Flight Procedures Cover Page	Task Action: FLIGHT CHECK	Task Type: IAP	Estimated Chart Date: 03/27/2020	APWS Task ID: E4E95038002748ADA4C2BF2237BF4A73	APWS Request ID: 5A245E1E25904FD09F45F84D1FEB3765
Procedure: RNAV (GPS) Y RWY 19 AMDT 1		Enroute: NO	Specialist: Bayse, Christine		Agreement Number:
Airport ID: KTEB	Airport Name: TETERBORO		Airport City: TETERBORO		State: NJ
Facility ID:	Facility Type:	Flight Inspection Remark Type: Hold FC Slot			
<p>Procedure Comments: 8260-1: MAXIMUM ALTITUDE RESTRICTION LOWER THAN CLEARANCE LIMIT ON MISSED APPROACH ACTIVE AIRPORT DATA USED FOR KTEB. CONTACT: GEORGE DAVIS 405-954-9960 OR WARDELL HENNING 405-954-9954</p> <p>12/17/19: THIS IS AN UPDATED COPY OF THE FORMS DEVELOPED ON 07/12/19. 1. UPDATED THE MISSED APPROACH INSTRUCTIONS FROM "(DO NOT EXCEED 210 KIAS UNTIL BUBGE) CLIMB TO 500 THEN CLIMBING RIGHT TURN DIRECT BUBGE, CROSS BUBGE AT OR BELOW 1500, THEN CLIMB TO 3000 ON TRACK 274.75 TO EXXAM AND HOLD, CONTINUE CLIMB-IN-HOLD TO 3000." TO "CLIMB TO 500 THEN CLIMBING RIGHT TURN DIRECT BUBGE, CROSS BUBGE AT 1500, THEN CLIMB TO 3000 ON TRACK 274.75 TO EXAM AND HOLD, CONTINUE CLIMB-IN-HOLD TO 3000". 2. REMOVED NOTE "CHART NOTE: WHEN CIRCLING TO

RNAV (GPS) Y RWY 19
TETERBORO (TEB)

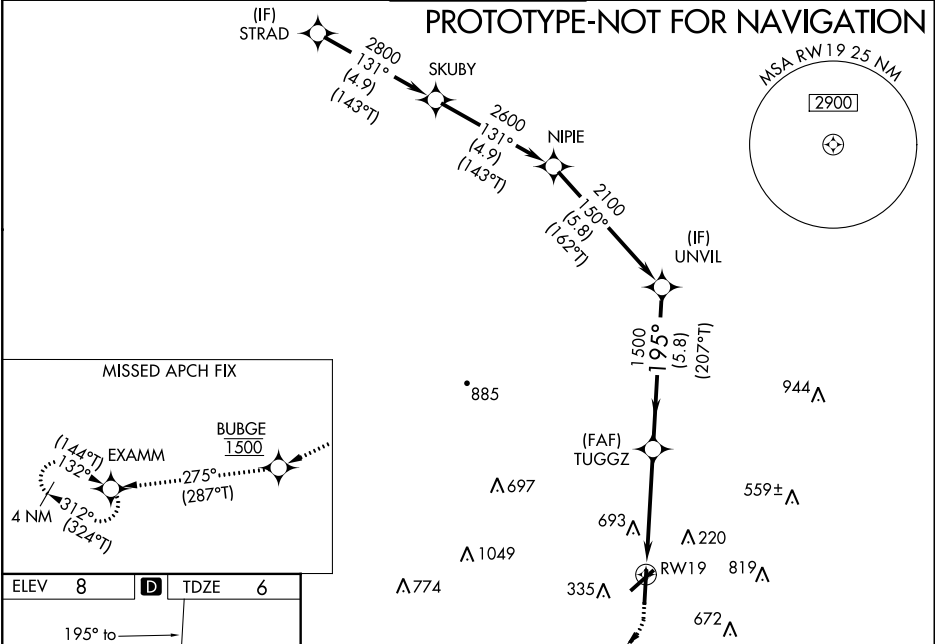
- Form 8260-3 Missed approach instructions "...cross BUBGE at 1500..." indicates a mandatory altitude, which is inconsistent with Additional Flight Data and Changes and Reasons item #18 on the form 8260-3 which specify a maximum altitude. Change to be consistent.
- Note "CAUTION: On missed approach, do not exceed 1500 until passing BUBGE" not addressed in ELS or otherwise required and should be deleted.
- Form 8260-3; Changes and Reasons #23 not consistent with Additional Flight Data entry. Should be "HOLD NW."

1. Note has been changed to say "mandatory" in additional flight data. There is an updated copy statement for this note that overrides the changes-reasons for 18.

2. Note "CAUTION: ON MISSED APPROACH, DO NOT EXCEED 1500 UNTIL PASSING BUBGE" has been removed.

3. Changes-reasons has been updated to the correct information due to the typo.
